**MONTGOMERY COUNTY HISTORIC PRESERVATION COMMISSION**  
**STAFF REPORT**

<b>Address:</b>	25 Quincy St., Chevy Chase	<b>Meeting Date:</b>	9/19/2017
<b>Resource:</b>	<b>Contributing Resource</b> Chevy Chase Village Historic District	<b>Report Date:</b>	9/12/2017
<b>Applicant:</b>	Bob Shorb (Karl Riedel, Agent)	<b>Public Notice:</b>	9/5/2017
<b>Review:</b>	HAWP	<b>Tax Credit:</b>	N/A
<b>Case Number:</b>	35/13-17CC	<b>Staff:</b>	Michael Kyne
<b>PROPOSAL:</b>	Window replacement

**SHORB  
RESIDENCE  
WINDOW  
REPLACEMENT**  
25 QUINCY ST.  
CHEVY CHASE, MD

W3-1

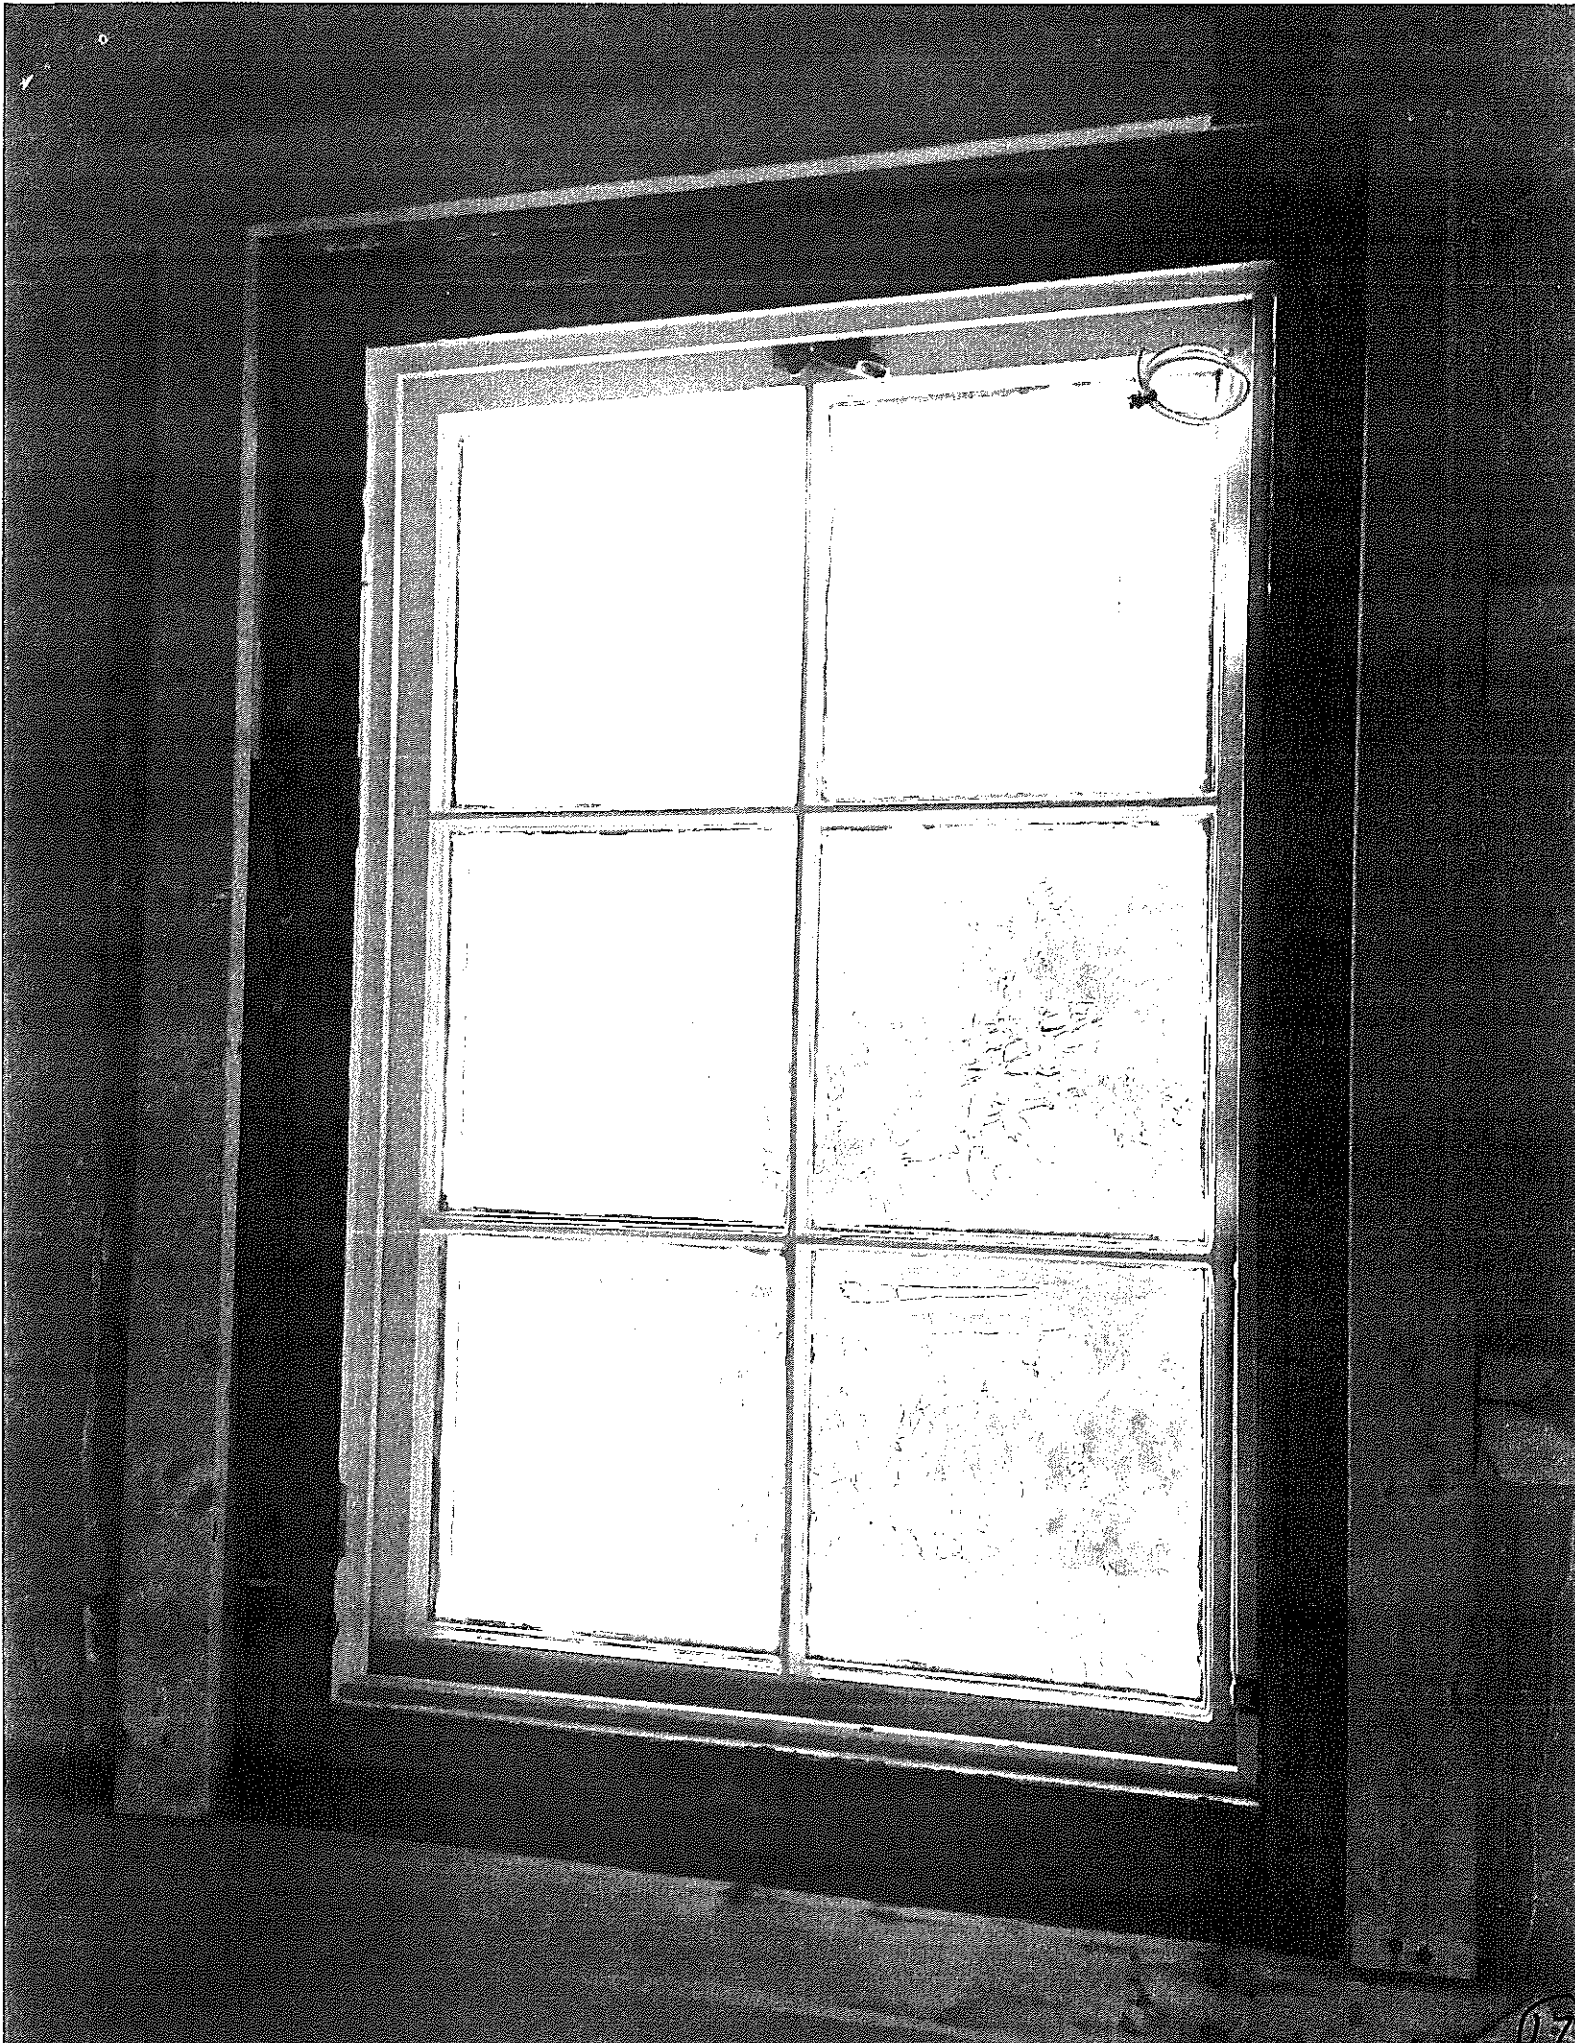
- (1) The pair of 3<sup>rd</sup> floor, gable end windows (W3-1 & W3-2) appear to be original to the house. They are located in a portion of the 3<sup>rd</sup> floor that was never conditioned space and the previous homeowner never installed storm windows at this location. Several of the sash cords are broken and the upper sash of the northernmost window will not stay closed unless it is pinned in place; there is a broken lite in the upper sash of the southernmost window. The sashes are loose in their tracks and there is a significant amount of air infiltration through these windows. Our request is to replace these two windows with new Marvin Clad Ultimate Double Hung – Next Generation windows fabricated to match the existing units.

Due to single pane  
exterior storm windows,  
these do not "read" like  
divided lite casements

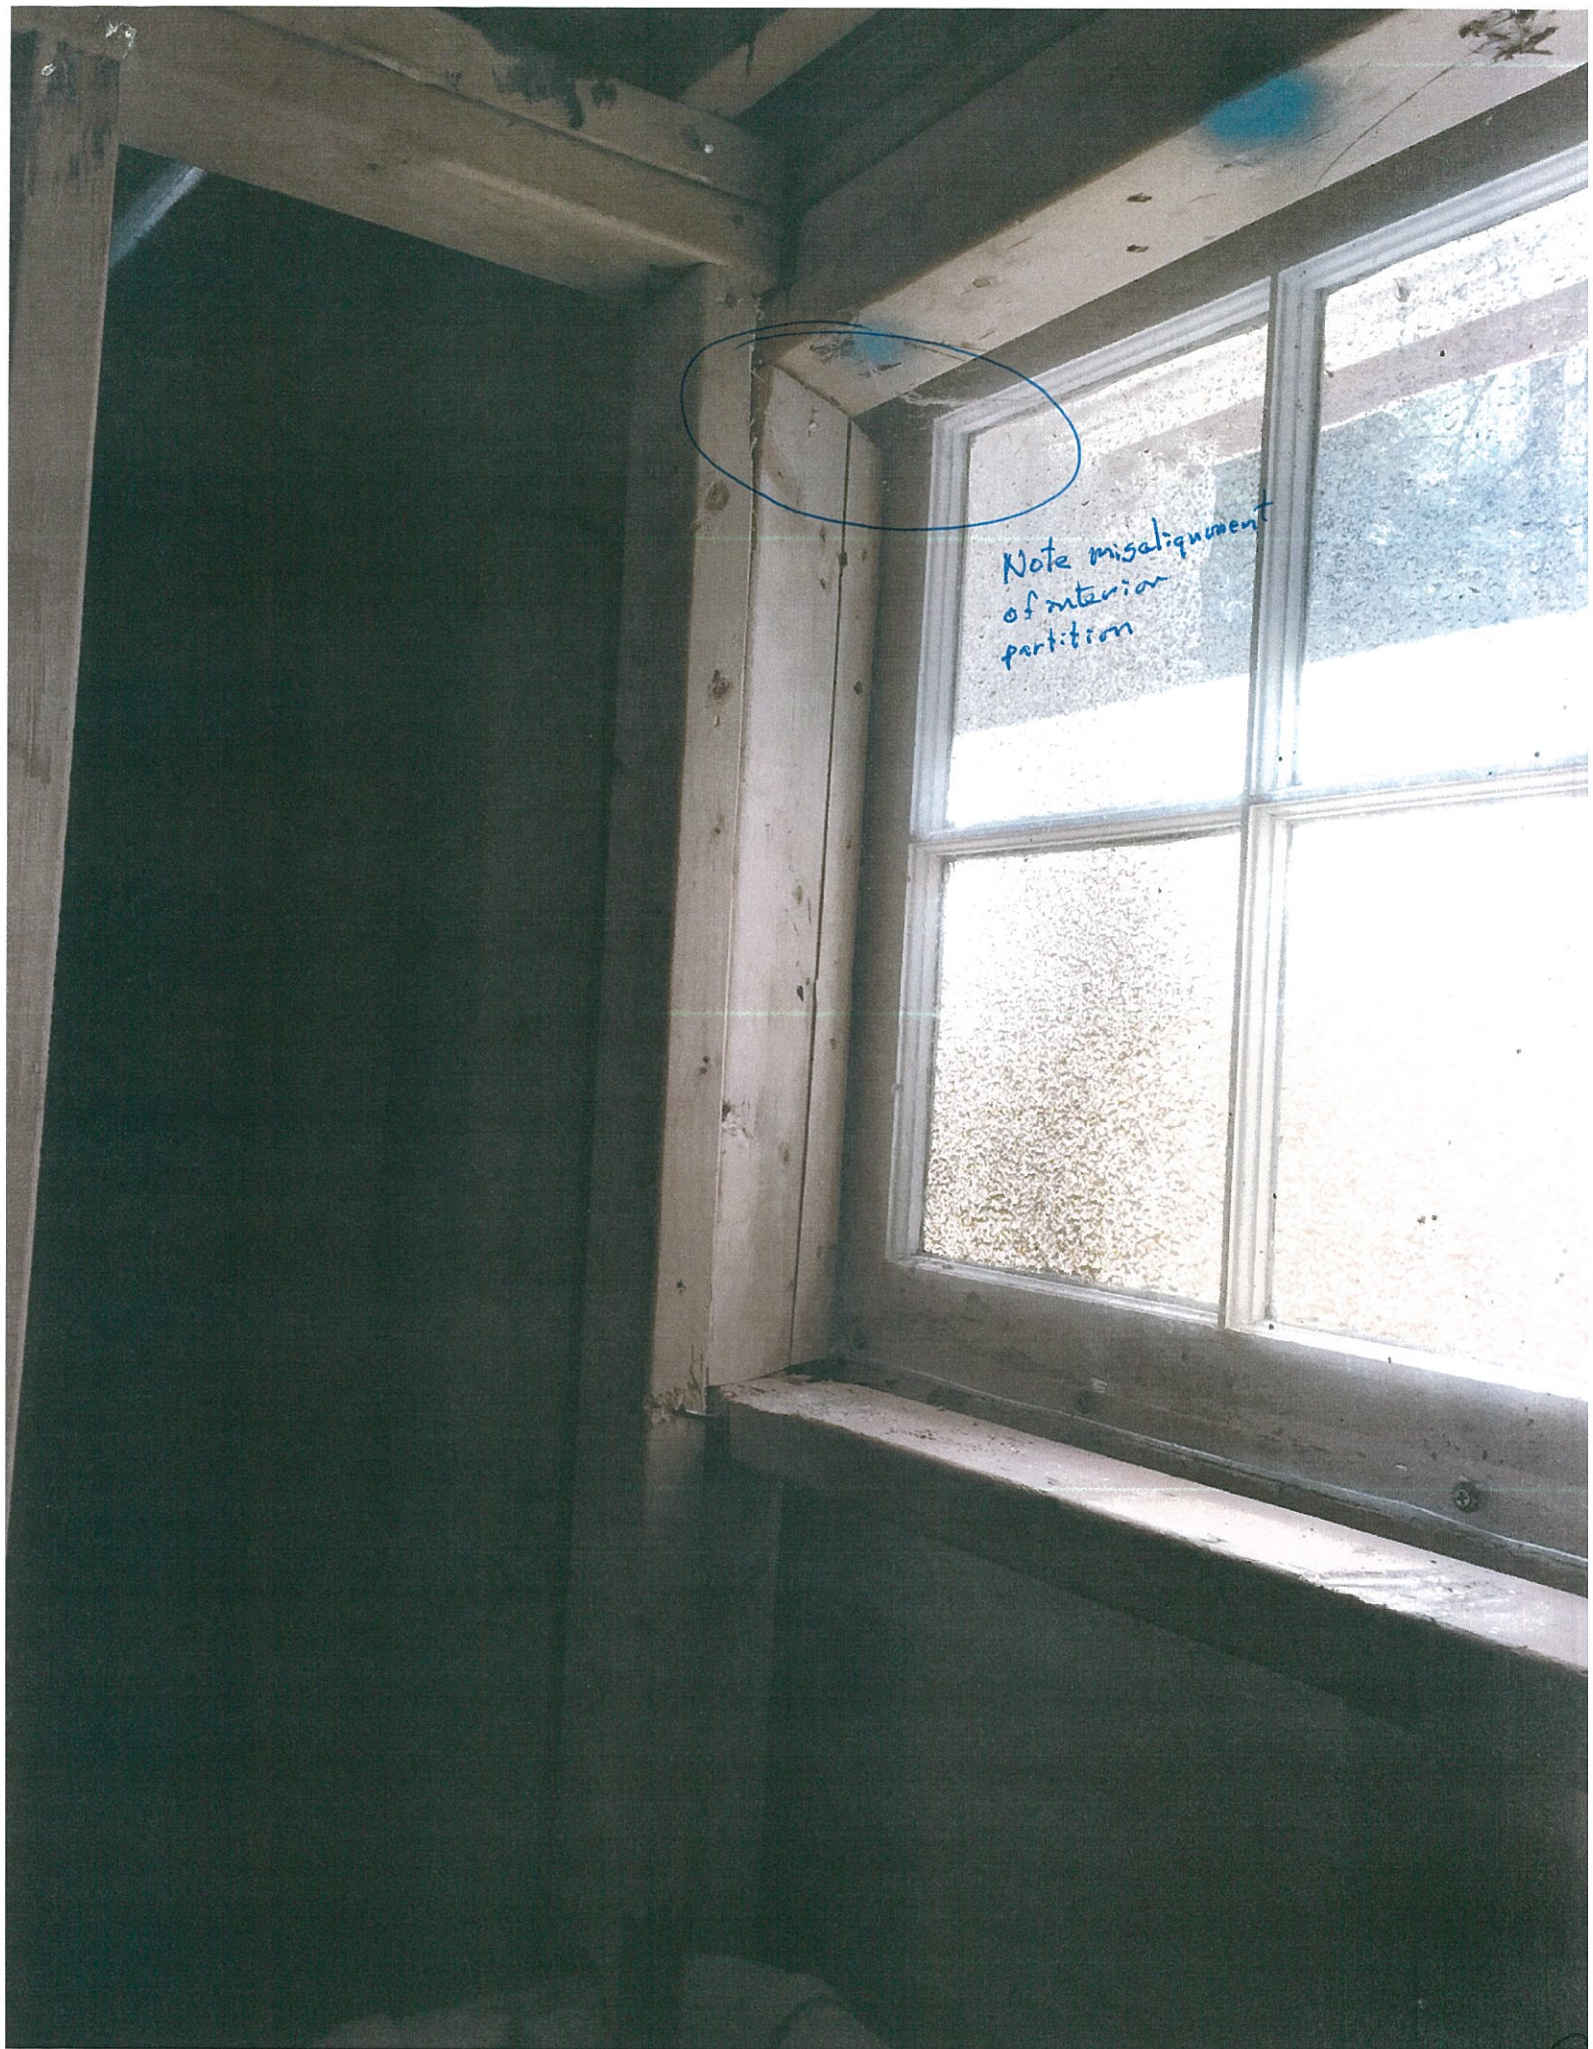
- (2) The clerestory utility window in the basement (WB-1) is a fixed awning window with the lites arranged in a “3x2” matrix; it appears to be original to the house. When the house was originally built, the entire lower level was unpartitioned and there were 5 such windows in the basement; 3 of these windows have been displaced by adjacent construction, 1 was replaced by a much larger window (and associated window well to accommodate code mandated exiting requirements), and this window remains. The basement has now been, as part of the originally approved scope of work, partitioned into many different spaces. As can be seen in the attached photograph, the interior partition that abuts the exterior wall in which the window is located encroaches into the masonry opening where the window is located. Unfortunately, the room on the other side of this wall is a bathroom, the layout of which is defined by the below-slab plumbing rough-in which was in place before this dimensional bust was discovered, hence making the relocation of the wall impractical at this point. Additionally, the far side of this bathroom abuts the downturned steel beam that runs laterally from one side of the basement to the other (it carries the load of the first floor joists which run front to back). The bathroom was configured so that this beam was located within a partition. Accordingly, even if we didn’t have the plumbing rough-in issue, shifting the bathroom 6” to the south would result in this beam, the bottom of which is approximately 6’7” AFF,

projecting below the ceiling within the tub area of the bathroom. We are asking permission to remove the existing awning window, fill in the southernmost 6" of the existing masonry opening, and install a Marvin Clad Ultimate Awning window which would replicate the existing window but would be 6" narrower in width. This would allow the interior partition which is misaligned with the existing window opening to cleanly abut the existing exterior wall.

Note misalignment  
of interior  
partition
